PLANNING PERMIT APPLICATION
APPLICATION FOR PLANNING APPROVAL UNDER SECTION 51,
LAND USE PLANNING & APPROVALS ACT 1993

Enquiries: Townplanner
Phone: (03) 6443 8305
Our Ref: 7087735 & DA 53/2018

I advise that under Section 54 of the Land Use Planning and Approvals Act 1993 Council seeks further information in relation to application DA 53 for a Demolition of existing dwelling, replacement dwelling and retaining walls at 15 Hepples Road and 13 Hepples Road BOAT HARBOUR BEACH. In order to progress the assessment of your application, please provide the following:-

Issue	02
Date	13 February 2019
Project Name	Hepples Road Dwelling
Project Number	17.077
Author	George Walker
Document	Response to Council Request for Further Information

PLAN SHOWING NEW
RETAINING WALLS &
PLUMBING PLAN
FOR 15 HEPPLES ROAD

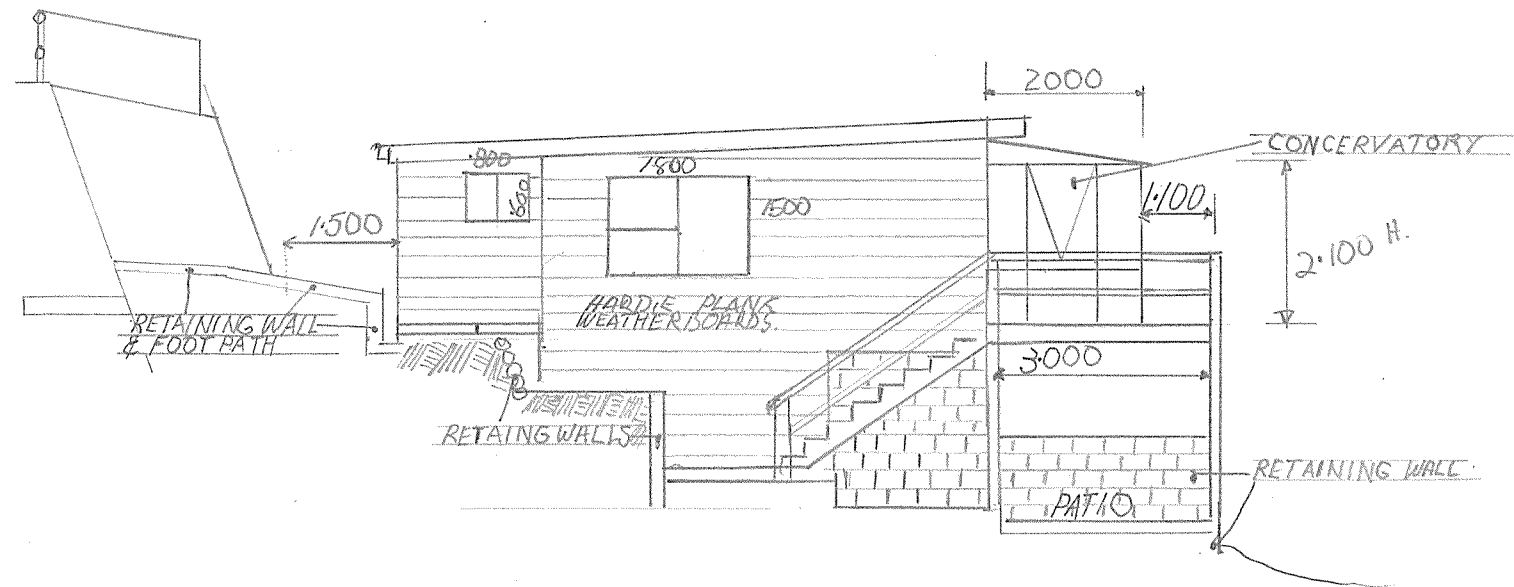
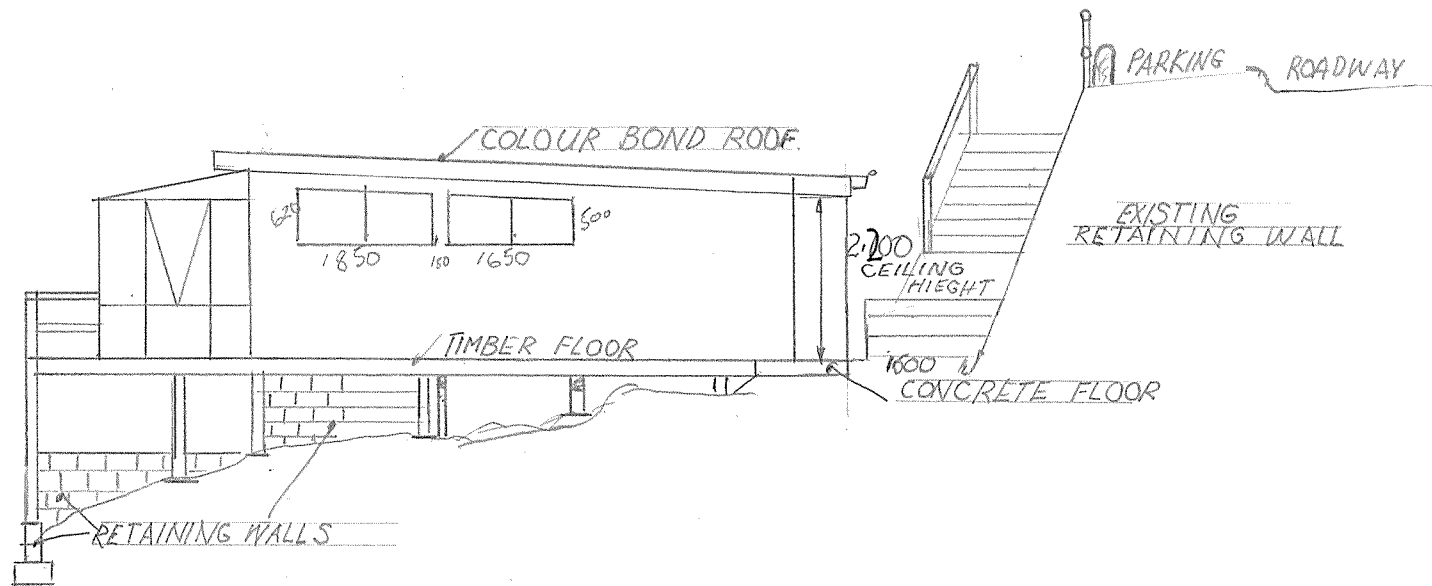
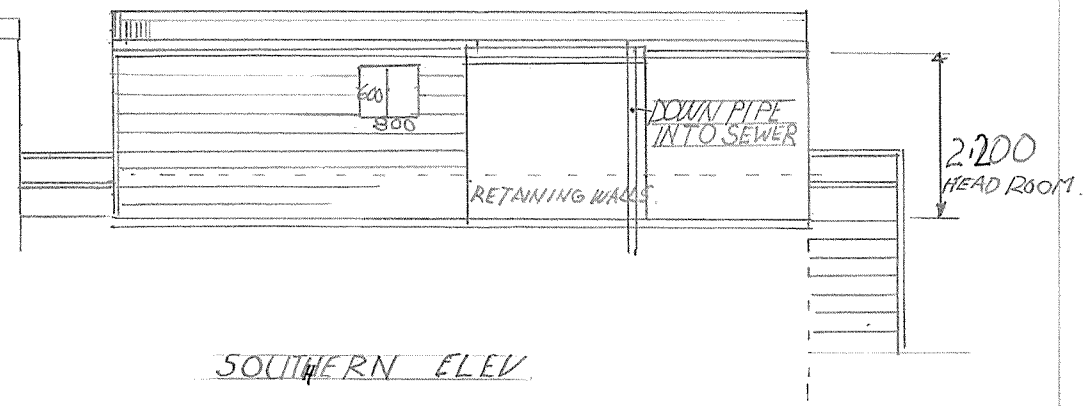
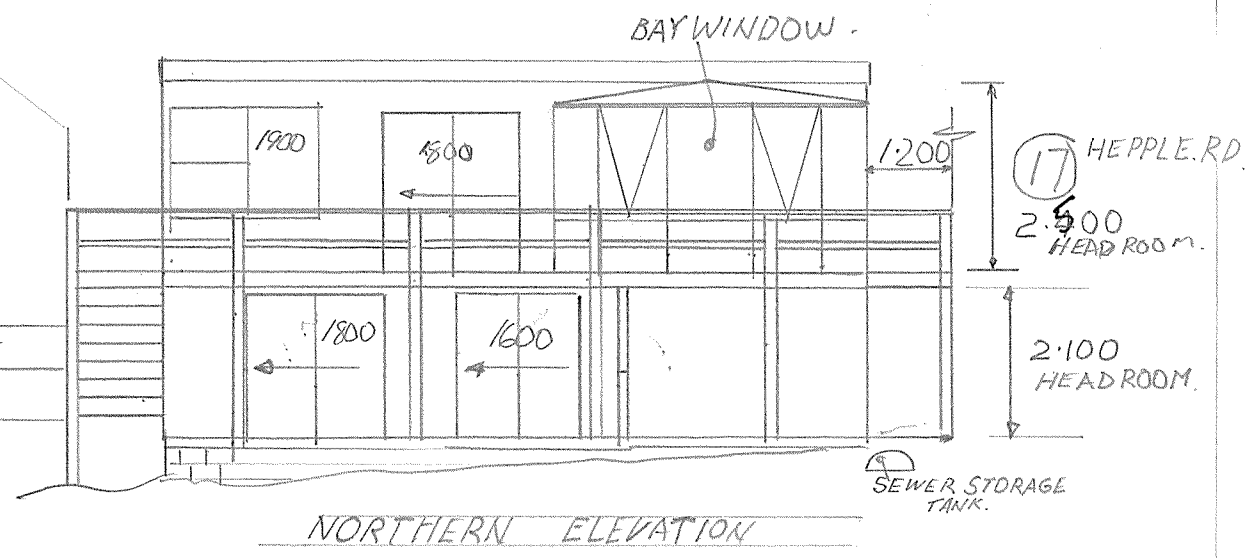
- Proposal drawings showing a new retaining wall are not clearly marked with an appropriate scale. Please provide details with an elevation view and section of all retaining walls at an appropriate scale. No details have been provided to date for the retaining wall crossing the boundary of 13 and 15 Hepples Road.
